PRELIMINARY CONCEPT - SITE PLAN

80 BED ADULT CARE HOME
BEAUFORT, SOUTH CAROLINA

**CITY OF BEAUFORT
DESIGN REVIEW BOARD
Staff Report
Meeting of March 12, 2015**

Case Number: 15-04 DRB.1
Project: Meridian Assisted Living on Lady's Island
Property Address: 93 Sea Island Parkway
Parcel #: R123-015-000-0915-0000
Zoning: Neighborhood Commercial
Design District: Lady's Island Village Center Design District
Type of Review: Conceptual Review – New Construction

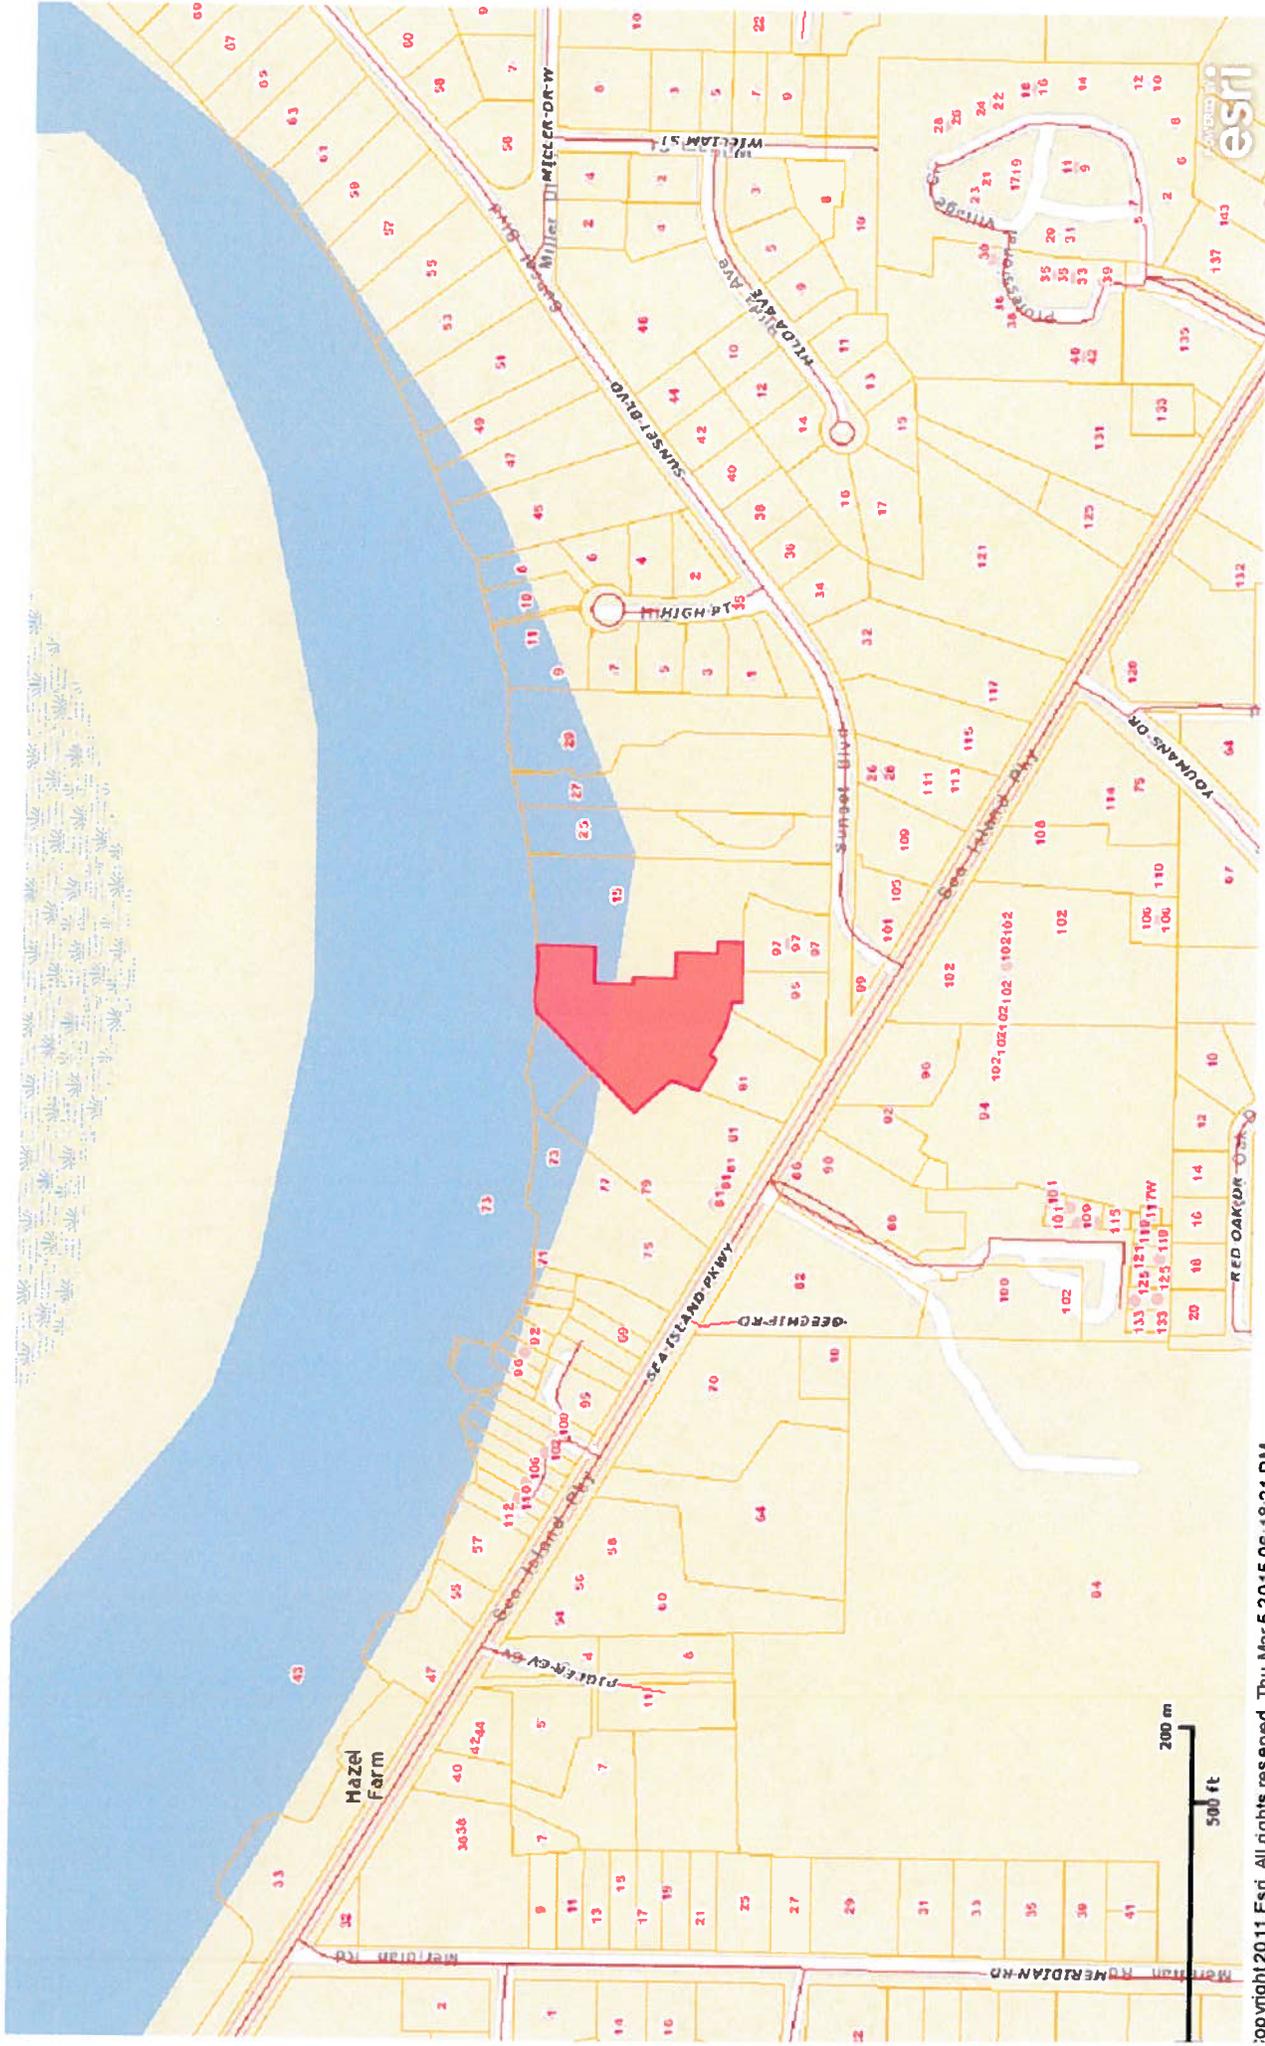
- The general size, mass and scale of this building meets the requirements of the UDO.
- With regards to detailing and materials, the general concept of breaking up the long 220'+ building elevation is appreciated. The city advocates authenticity in building materials and details, particularly when working to achieve a lowcountry vernacular. Some items to consider, based upon these conceptual renderings are:

- Increase the bandboard at the brick water table line, and decrease the board at the next level above.
 - On the entry portico, ensure that the edge of the beam is flush with the face of the column.

- Consider reducing the number of siding materials to one, either lap or board and batten. If an alternative material is desired in the gable, consider a horizontal butt board or something more consistent with the horizontal lap.

- When there is a pair of windows, they should be treated as individual windows rather than an assembly, and have a 4" trim board between them.
 - Utilize a consistent header and sill detail on all windows, both singles and pairs.

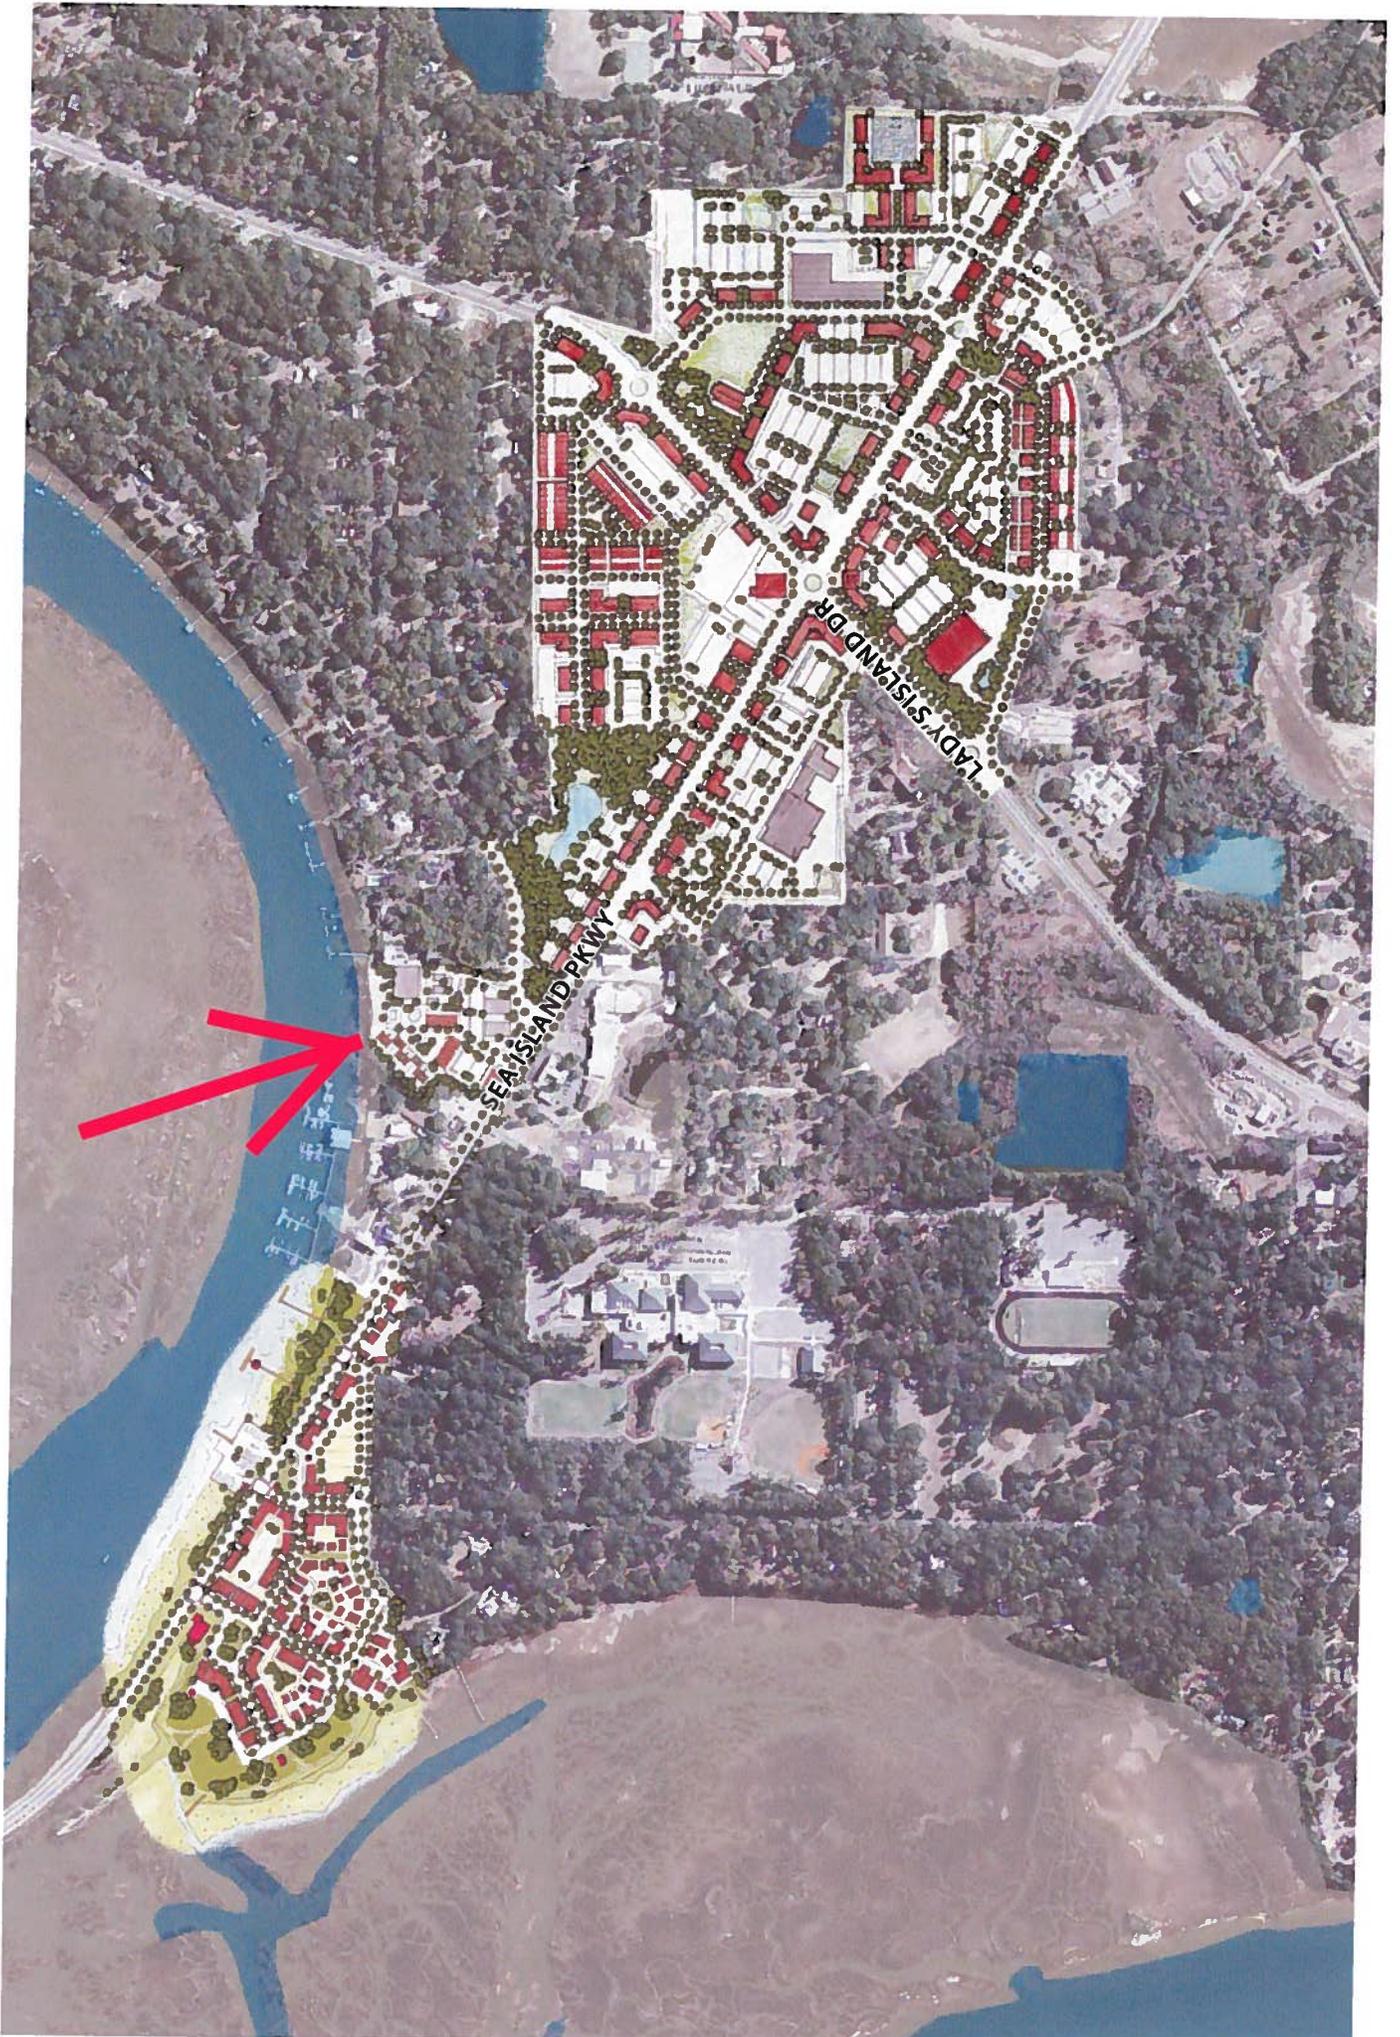
- Avoid the “pork chop” eave detail by considering an open rafter tail. This may be particularly appropriate with the gable, portico and bracket detailing you’re showing on other places throughout the building.
